**STAGE 1 DEVELOPMENT APPLICATION
PLANNING ASSESSMENT REPORT -
D/2014/755/A**

286-296 SUSSEX STREET, SYDNEY

DEVELOPMENT APPLICATION: 286-296 SUSSEX STREET SYDNEY**FILE NO:** D/2014/755**DEVELOPMENT APPLICATION NO:** D/2014/755**SUMMARY****Date of Submission:** 28 May 2014**Amended** 6 January 2015**Applicant:** Giovanni Cirillo**Architect:** Tzannes Associates**Owner:** Ausbao (286 Sussex St) Pty Limited**Cost of Works:** \$75,621,700**Proposal Summary:** The proposal (as amended) seeks consent for a Stage 1 concept proposal, including the following:

Figure 16: Proposed separation distances achieved across DrUITT Lane

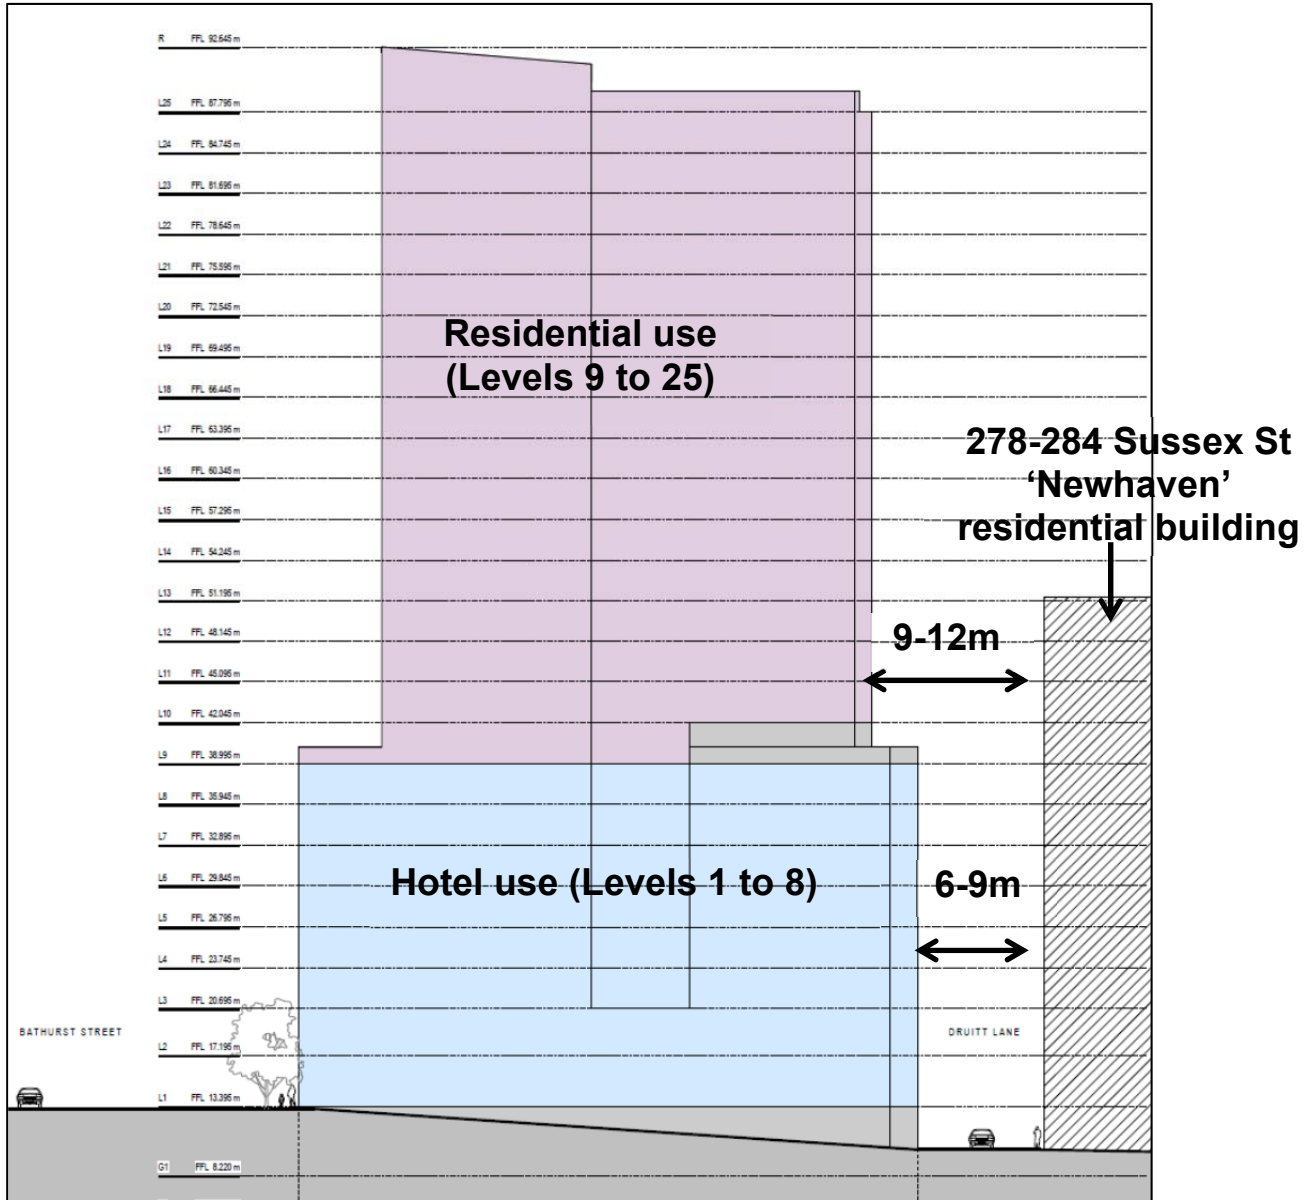
46. As detailed in **Figure 16**, below, the podium (ground to Level 8) of the subject development is proposed to have a nil setback along the northern boundary of the site to DrUITT Lane. This equates to a separation between the future hotel use in the podium of the proposed development and the existing residential building to the north, known as 'Newhaven' (278-284 Sussex Street), of between 6 to 9 metres.

49. In this instance, a separation of 7 to 9 metres is achieved from the proposed northern wall of the podium to the south facing windows of the Newhaven building (located on the opposite side of DrUITT Lane). A review of the floor plans of the Newhaven building has revealed that the windows that are directly oriented south to front the lane are bedroom windows and not the principal living windows of these apartments.

51. In this instance, the separation distances across the lane (for the podium levels) is considered to be adequate as:
- There is only one location where an area of principal open space or living room would not be separated from a commercial use by the desired separation of 9 metres. It is noted that both the living room windows and its associated balcony are not oriented to the south (towards the site) but rather towards the southwest (i.e. towards Sussex Street);
 - The existing commercial building on site is built to the northern laneway boundary of the site and already contains windows on this northern elevation (as illustrated in **Figure 19**, below). As a hotel is defined as a commercial use, the proposal is not resulting in any greater privacy impacts than the existing situation;

- (c) It is considered that those areas with 6 metre separation could be resolved through skilful design of the detailed internal planning of the future hotel, and through the architectural treatment of the podium through both the competitive design process and the Stage 2 Development Application.

52. As detailed in **Figure 16**, above, the tower floor plate (Levels 9 to 25) of the subject development have been setback 6 metres from the centre of Druitt Lane, in accordance with the provisions of Section 5.1.2.3 of SDCP 2012. The provision of this setback achieves a separation between the future residential apartments within the proposed tower and the Newhaven apartments of between 9 to 12 metres.

Figure 17: Locations where separation between proposed podium (hotel use) and adjacent residential building across lane is 6 metres

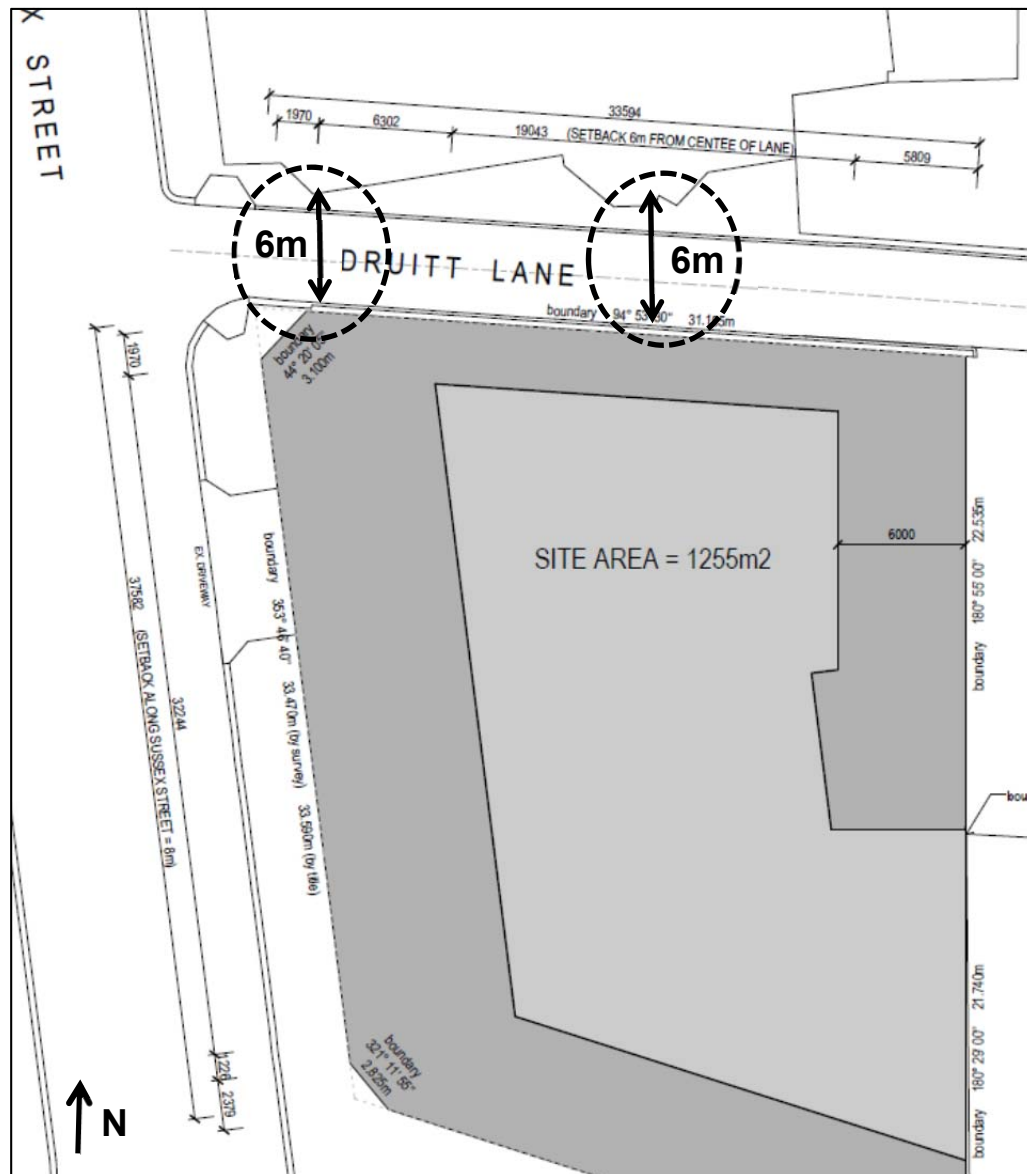
50. Where the separation between the buildings is reduced to a minimum of 6 metres, this is limited to two locations along the facade, as illustrated on **Figures 17** and **18**, below, with these being to a blank side wall and the other to the side elevation of a balcony.

Figure 20: Analysis to illustrate retention of outlook from Newhaven apartments

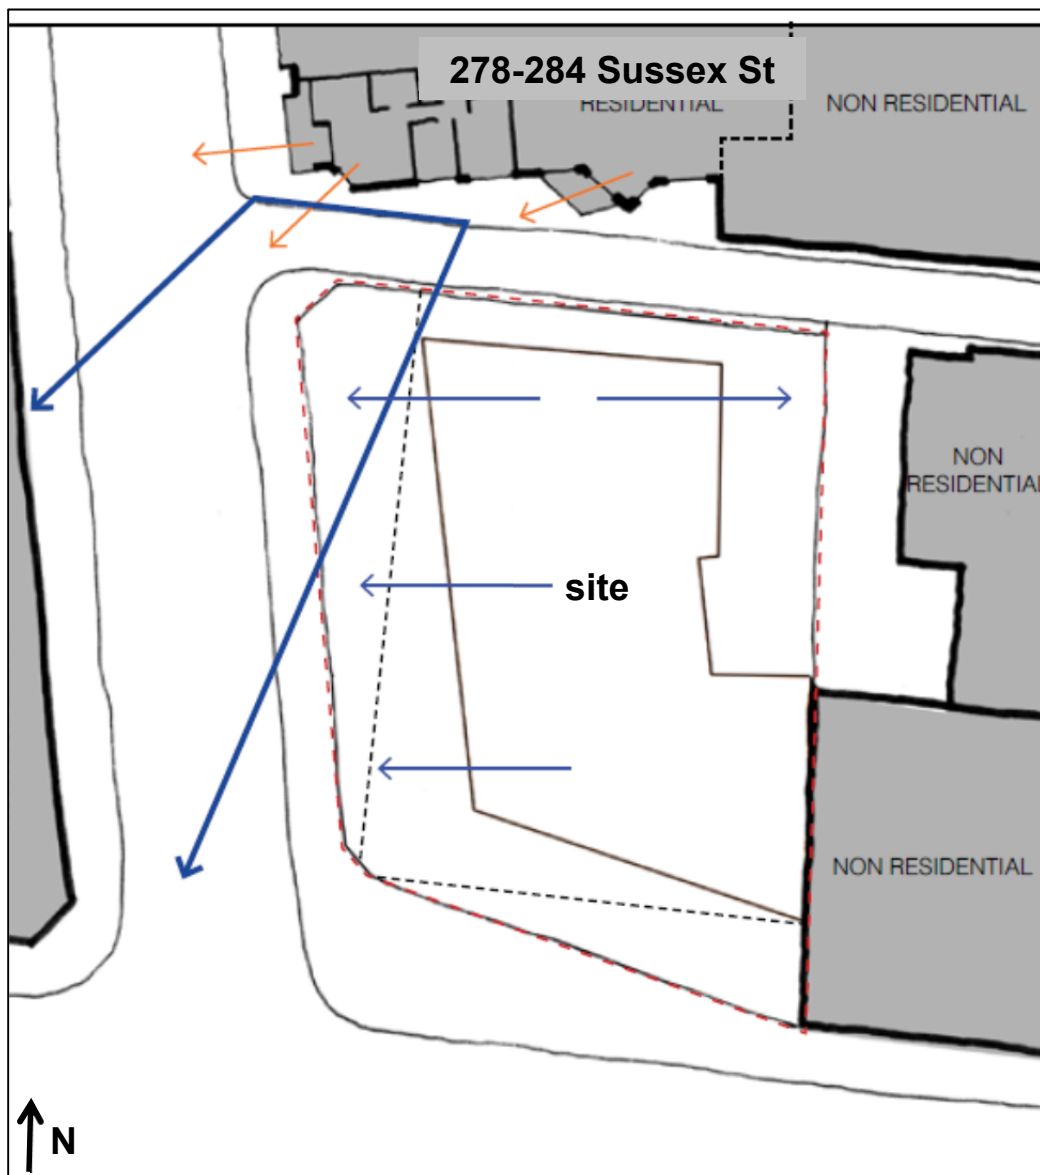
- (d) as is demonstrated in **Figure 20**, below, the width of the future tower on the subject site would limit a maximum of two apartments to this northern face, and it could reasonable be assumed that each of these apartments will be designed so that its oriented to either the east or west, not to the north. Therefore, it is considered that the 4 floors where there is an interface between the buildings across the lane could be skilfully designed to address privacy and overlooking;

- (e) with regard to outlook from the southern apartments within the Newhaven building, as demonstrated at **Figure 20**, below, the siting of the tower envelope on the subject site would not preclude the view and amenity from the principal living areas and open space of these units from being maintained.

Figure 21: Proposed tower setback from the eastern side boundary

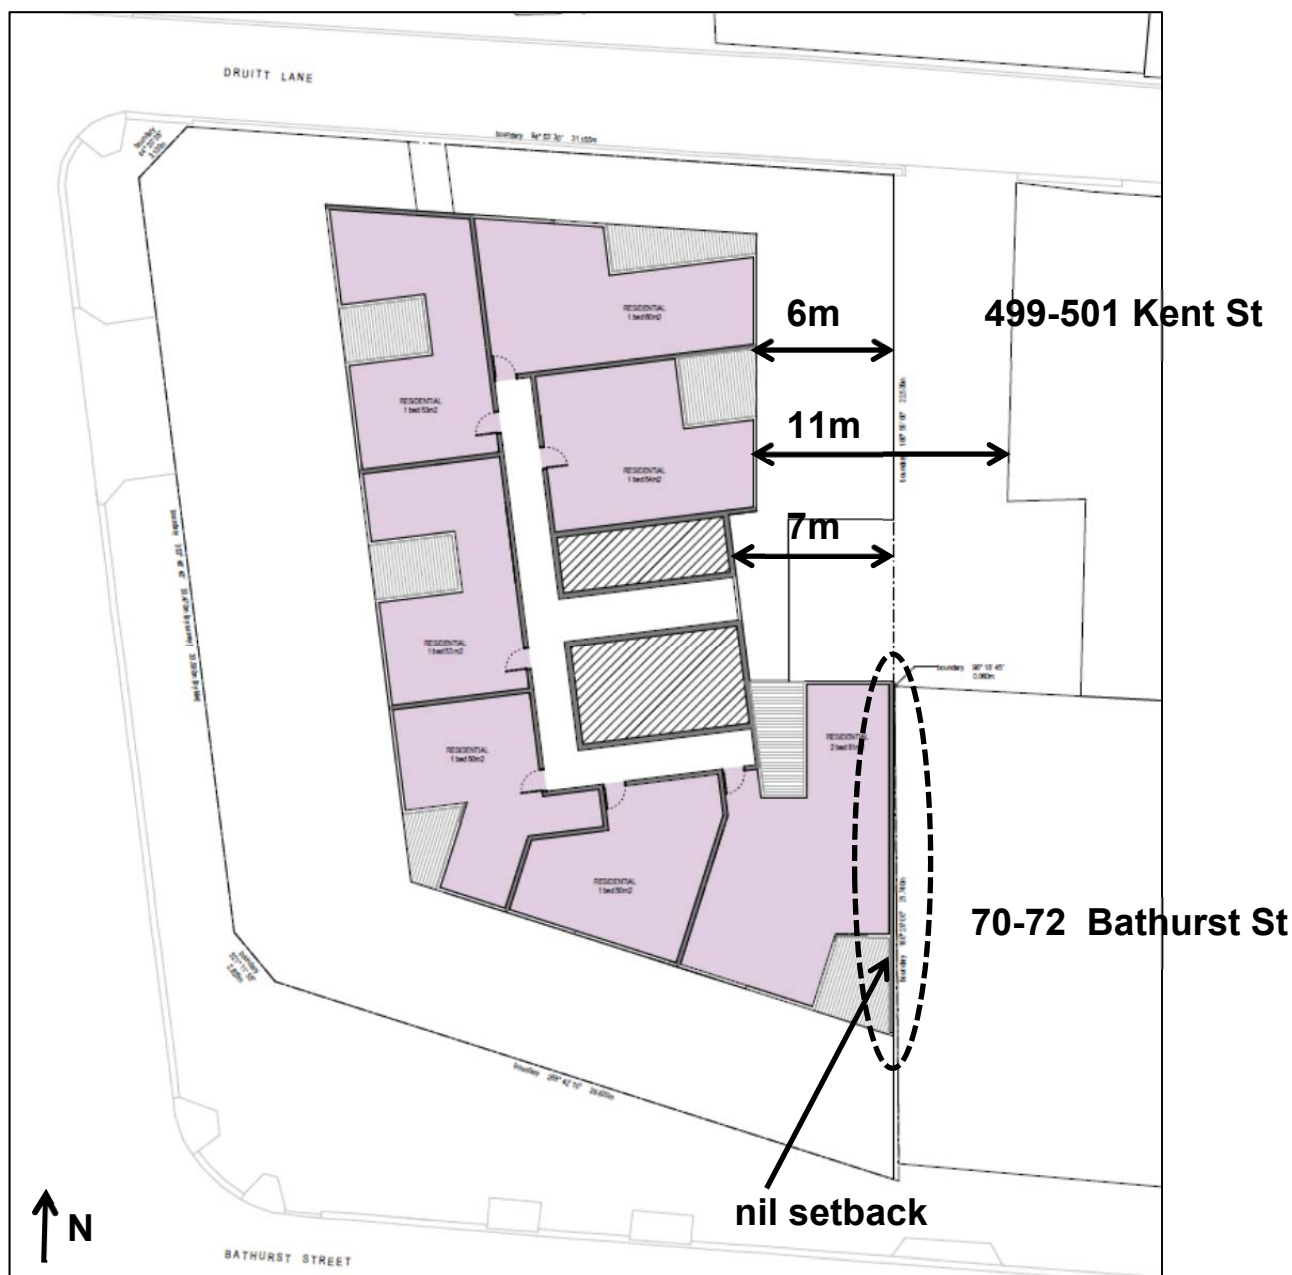
55. The proposed development has been designed with the following setback to the side (eastern) boundary (refer to **Figure 21** below):
- (a) a nil side setback for its podium levels (up to Level 8);
 - (b) a variable tower setback (from Levels 9 to 25) between:
 - (i) a nil setback adjacent to its boundary with 70-72 Bathurst Street; and
 - (ii) a 6-7 metre setback adjacent to its boundary with 499-501 Kent Street.

56. With regard to the nil side setback for the podium levels, no objection is raised in this instance to this design, as:
- the podium height will generally align with the existing blank western side wall of the adjacent commercial building at 70-72 Bathurst Street;
 - the existing heritage listed building at 499-501 Kent Street is separated from the proposed podium wall by approximately 5 to 5.5 metres, being the width of the rear cart way of the heritage site. This separation is generally consistent with the 6 metre setback provisions of Section 5.1.2.2 of SDCP 2012 between commercial land uses; and

Figure 22: Northern elevation illustrating the relationship to the adjacent heritage item to the east of the site at 499-501 Kent Street

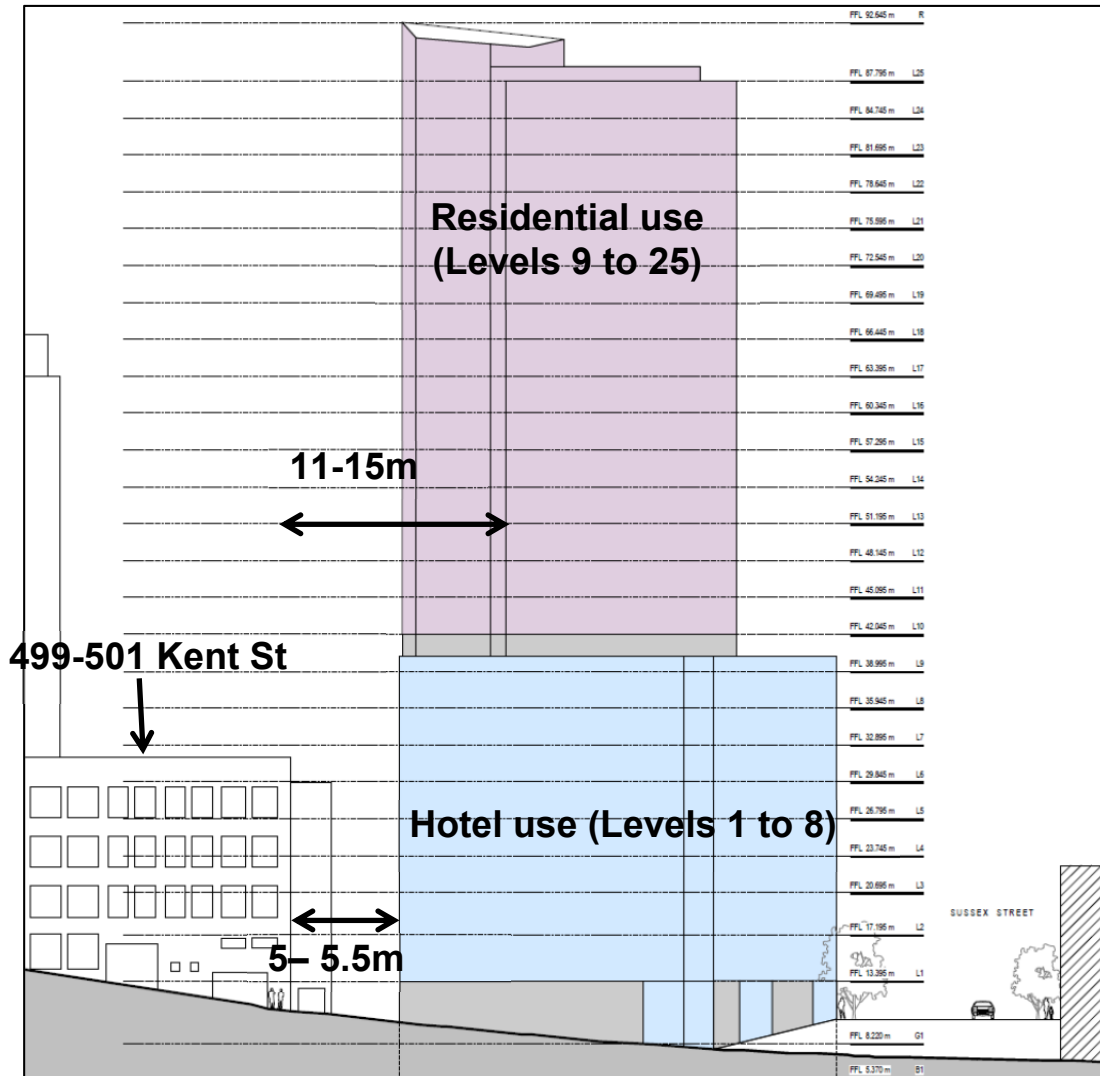
58. As detailed on **Figure 22**, above, a portion of the tower (for a length of 15 metres) is proposed with a nil setback adjacent to the site's side boundary with the commercial building at 70-72 Bathurst Street. The indicative floor plans submitted with the application demonstrate that a blank facade would be presented to the east, and that the future apartment accommodated adjacent to this boundary would be oriented north-south. No objection is raised to the proposed nil setback at this location as it is consistent with the setback provisions of the DCP and does not sterilise the development potential on the adjacent site, which is able to orient any windows in a future tower on its site in a north-south direction.

Figure 23: The proposed vehicular access location off Sussex Street

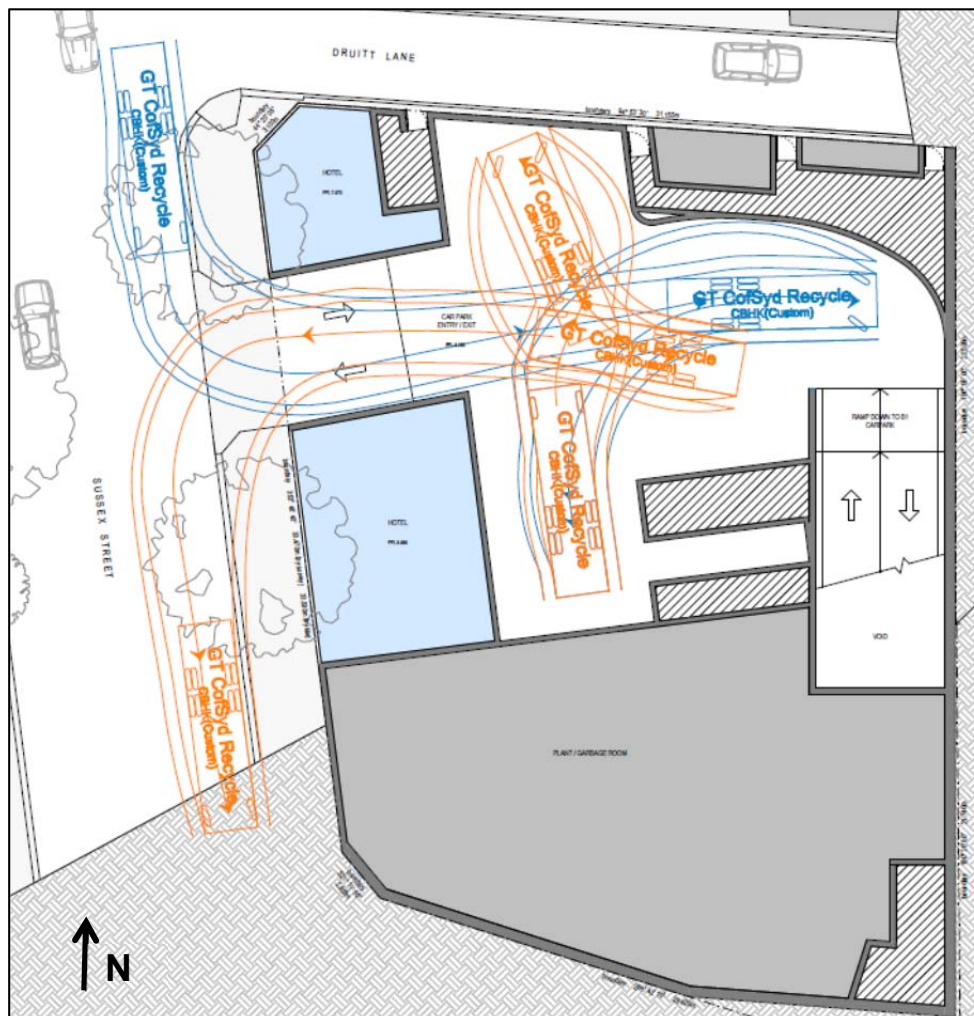
64. Following a preliminary assessment of the application, the Applicant was advised that the City's preference from an urban design, pedestrian safety and traffic point of view, was that vehicular access location for the future building should be relocated to the Druitt Lane frontage of the site. It was advised that consideration may be given to the Sussex Street driveway in the event that sufficient justification was able to be provided to demonstrate that service and waste collection vehicles would be unable to access and service the site via the lane.

66. This additional information has been reviewed by the City's Transport Planner, who has advised that the amended scheme has not adequately explored genuine vehicular access options from Druitt Lane. It has also been noted that the City's garbage trucks already travel along Druitt Lane to service other properties in the vicinity of the site.

- (a) no consent is given to the vehicular access location via Sussex Street as illustrated on the architectural plans; and
 - (b) the design brief for the competitive design process encourage competitors to design a scheme which includes vehicular access via Druitt Lane. This can also allow competitors to give consideration to hotel drop-off and the laneway facade treatment/activation.
